Release 1: This release replaces previous versions.  
 June 05, 2015 Added image for SW14.

## DASHBOARD SWITCH BACK LIGHTING Prevost vehicles

On the vehicles affected by this bulletin, "Fast idle" and "Cancel First Reading Lamp" switches on the dashboard may not be wired to provide back-lighting. Modify the wiring to add the feature.

Figure 1

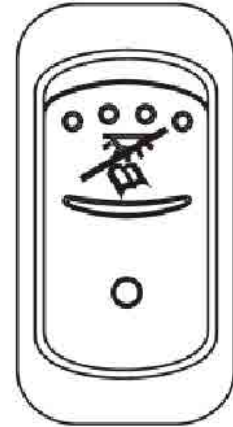
### Cancel 1<sup>st</sup> reading lamp switch (Fig. 1)

1. Use yellow wire 18 ga (6 in)
2. Crimp terminal 562769
3. Insert in cavity 9 of "Cancel 1st reading lamp switch" (SW13)
4. Remove pin 9 from "Reading light test switch" (SW5)
5. Cut off the existing terminal on this wire
6. Crimp new terminal 562769 with new wire *and* wire from SW5
7. Re insert in cavity 9 of SW5

Figure 2

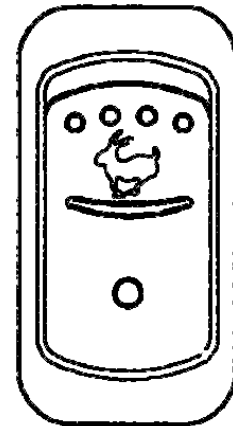
### Fast idle switch (Fig. 2)

8. Use yellow wire 18 ga (6 in)
9. Crimp terminal 562769
10. Insert in cavity 9 of "Fast idle switch" (SW14)
11. Remove pin 9 from switch 4 (SW4)
12. Cut off the existing terminal on this wire
13. Crimp new terminal 562769 with new wire *and* wire from SW4
14. Re insert in cavity 9 of SW4

Figure 3 SW13 re wiring

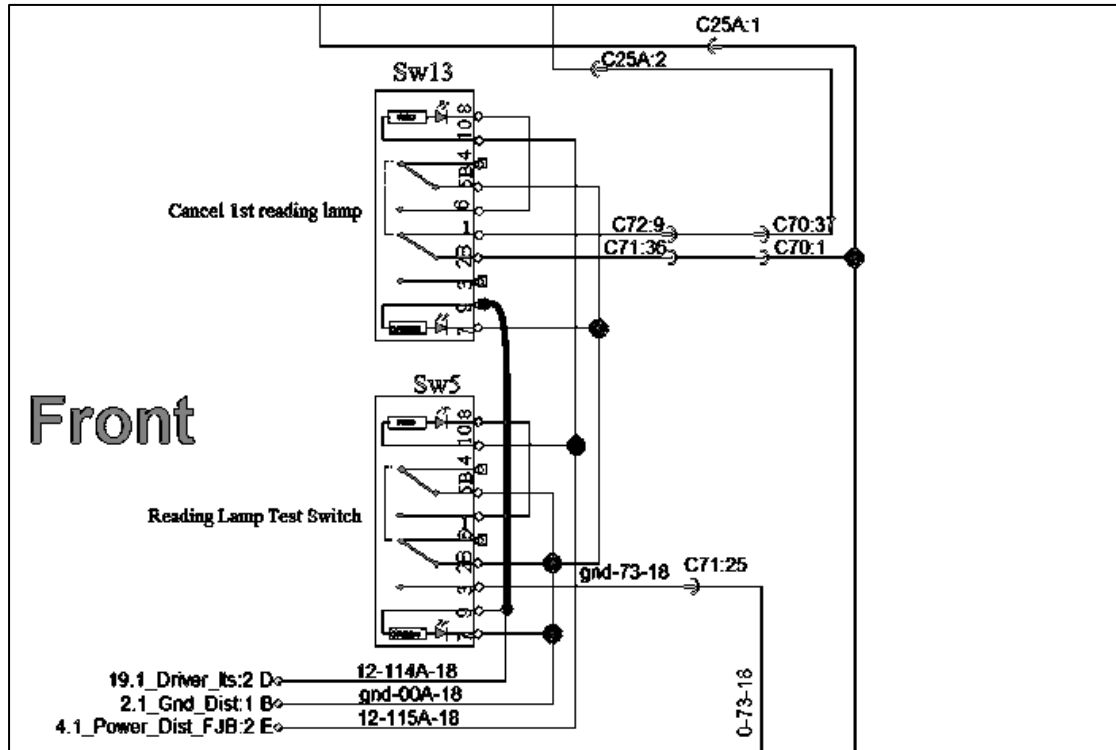
Modify wiring per instructions and figures 3 & 4.
